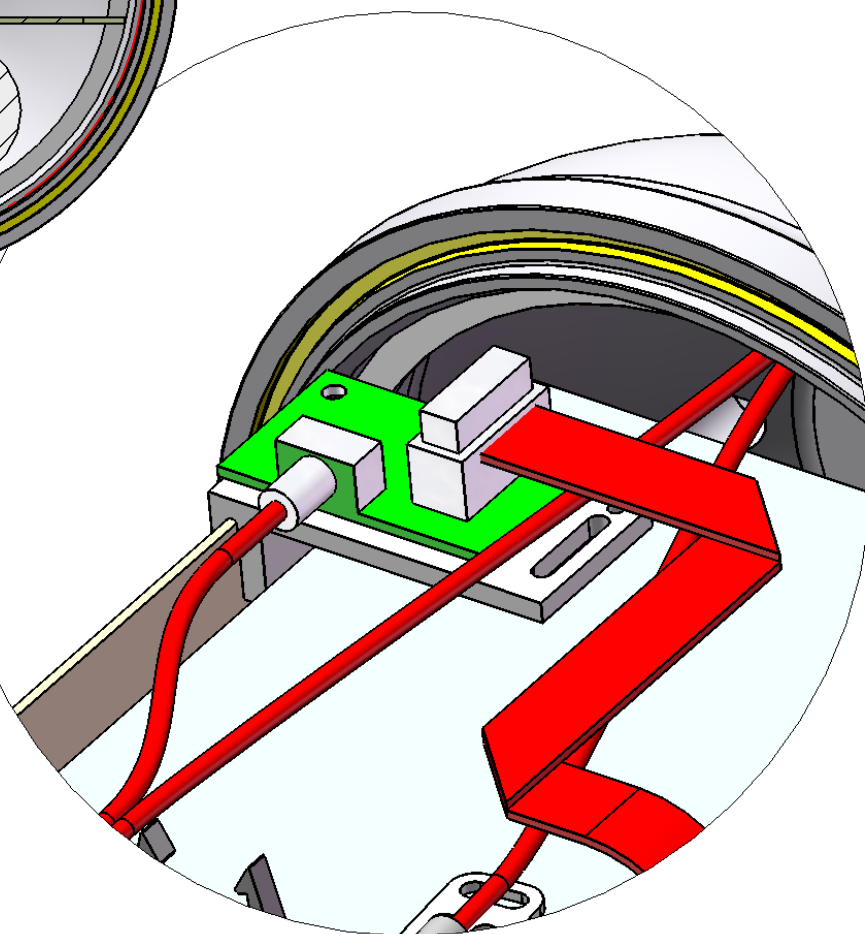
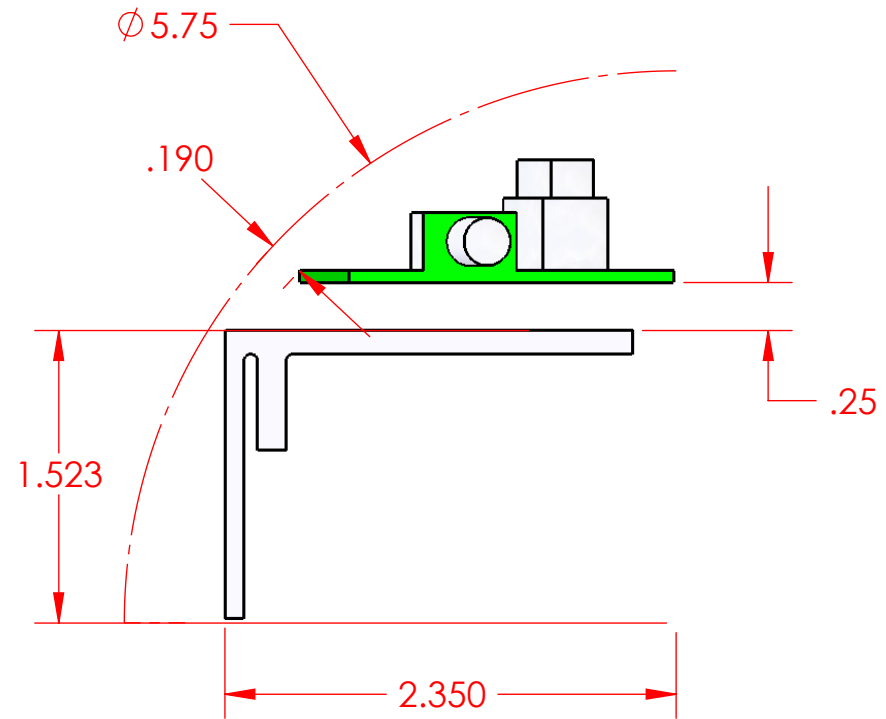
Suggestion:
 Add 3 new holes to reference support.
 Route fiber to light along right side
 of reference support.
 Allows 1/4" standoffs and increases
 board-to-housing from .054 to .190"
